**TRANSMITTAL OF THE MISCELLANEOUS SMALL STRUCTURES PHASE II PROJECT
REVISED IMPLEMENTATION PLAN FOR ABOVE-GRADE DECONTAMINATION AND
DISMANTLEMENT, REMEDIATION SCHEDULE AND AMENDMENT TO OPERABLE UNIT 3
INTEGRATED REMEDIAL DESIGN/REMEDIAL ACTION WORK PLAN REGULATORY
MILESTONES**

**MISCELLANEOUS SMALL STRUCTURES – PHASE II IMPLEMENTATION PLAN
DOCUMENT NUMBER 1751-PL-0004 (REV. 0) PCN1**

**INTEGRATED REMEDIAL DESIGN/REMEDIAL ACTION WORK PLAN
DOCUMENT NUMBER 2503-WP-0023 (REV.0) PCN5**

Document Control No. 2503-WP-0023 (REV. 0) PCN5

TABLE 2-4 Complex Remediation Sequence

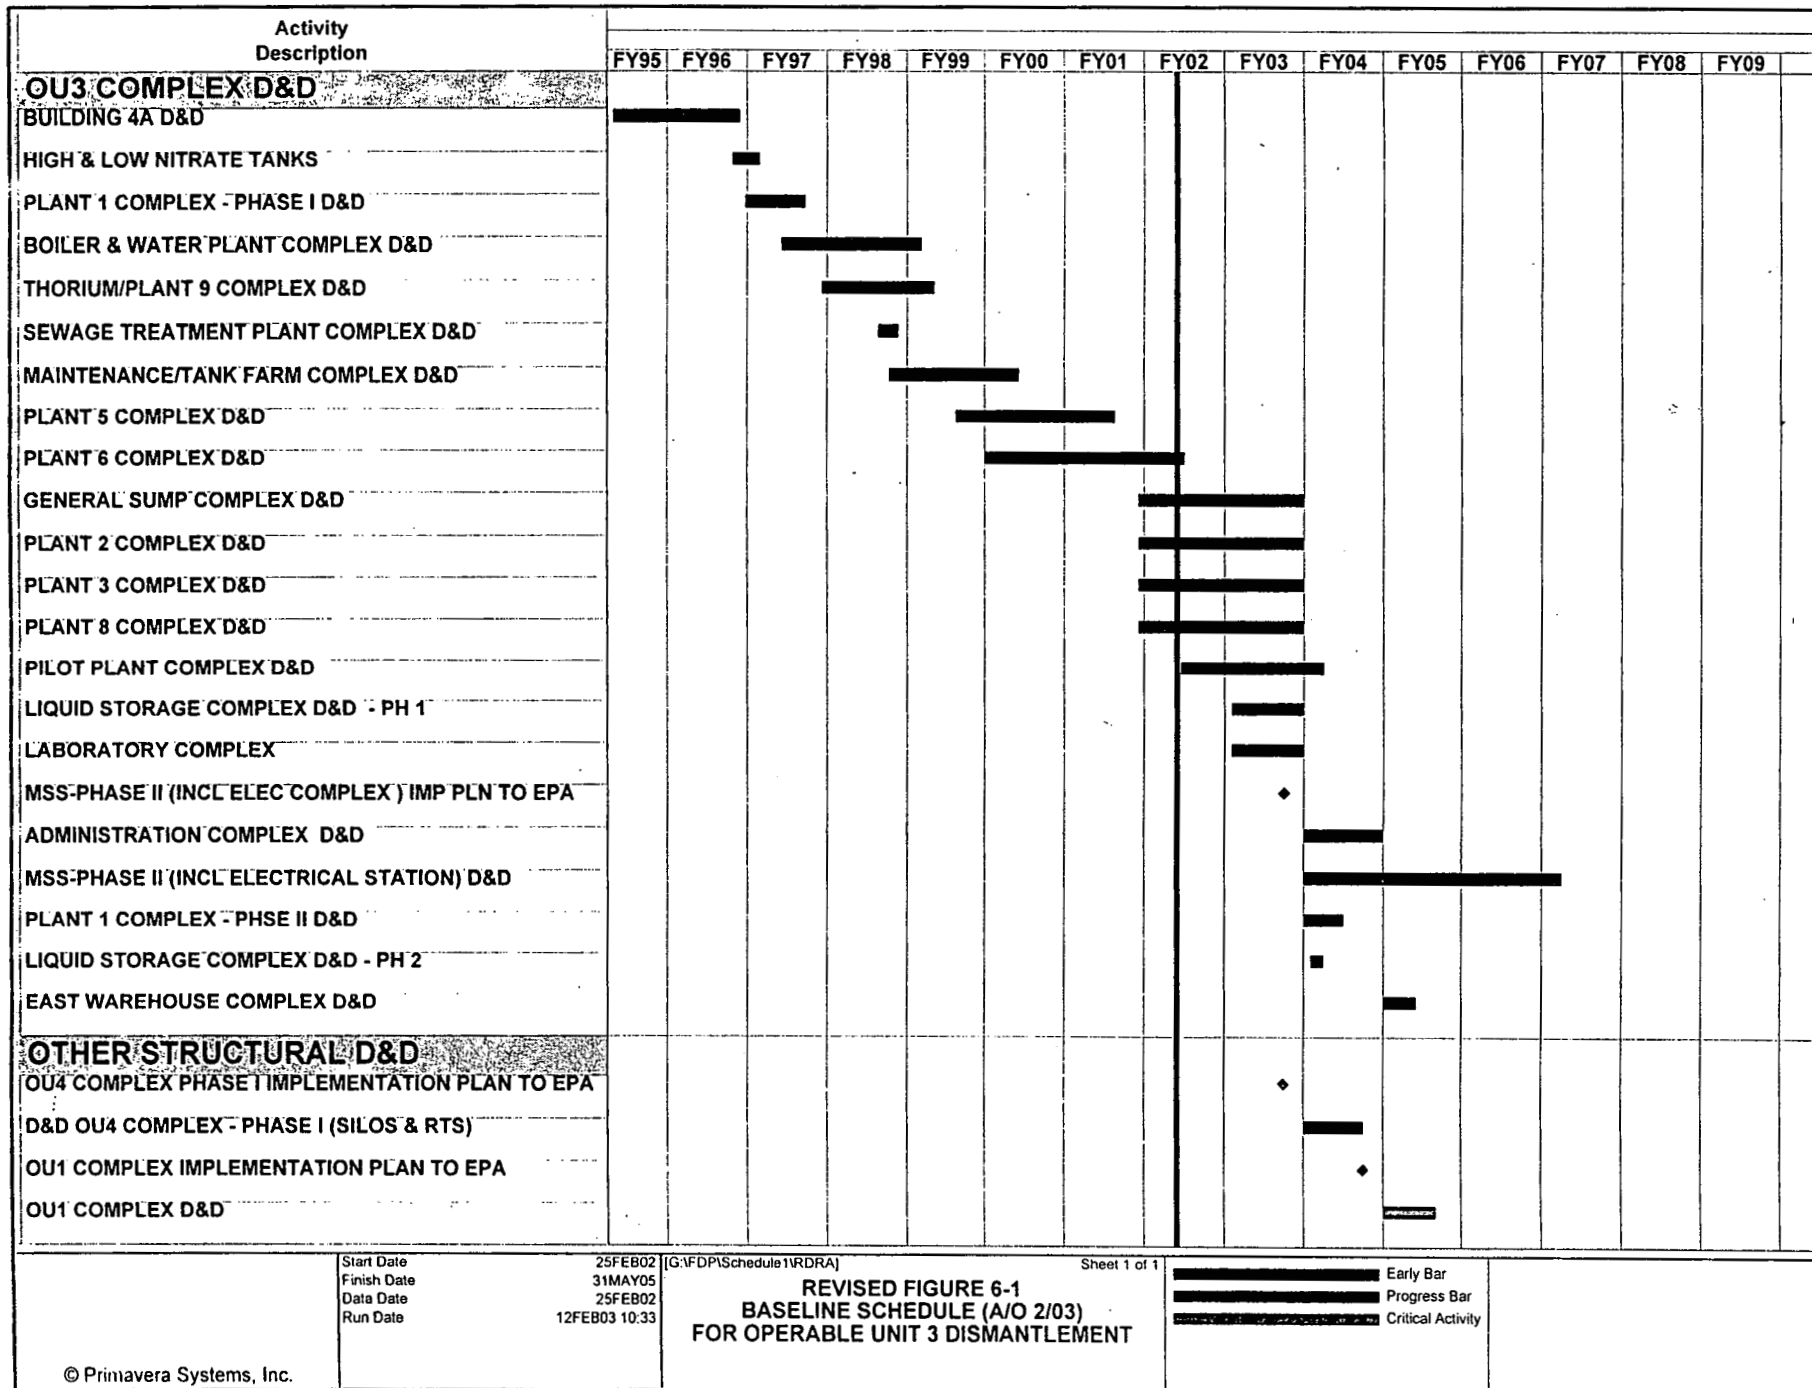
Additionally, this letter transmits an amendment to the regulatory milestones contained in the Operable Unit 3 (OU3) Integrated Remedial Design/Remedial Action (RD/RA) Work Plan. The amendment incorporates the addition of MSS - Phase II D&D to Tables 2-4, 6-1, and Figure 6-1 of the RD/RA Work Plan. Likewise, Tables 2-4, 6-1, and Figure 6-1 have been revised to reflect the completion of OU3 D&D activities to date.

0	5	February 2003	Amendment to OU3 Integrated RD/RA Work Plan regulatory milestones; pp. 6-3/6-4, 6-7/6-8 and complex remediation sequence p. 2-15/2-16 (resulting from the addition of Miscellaneous Small Structures Phase II D&D activities and revision of completed D&D activities to date).
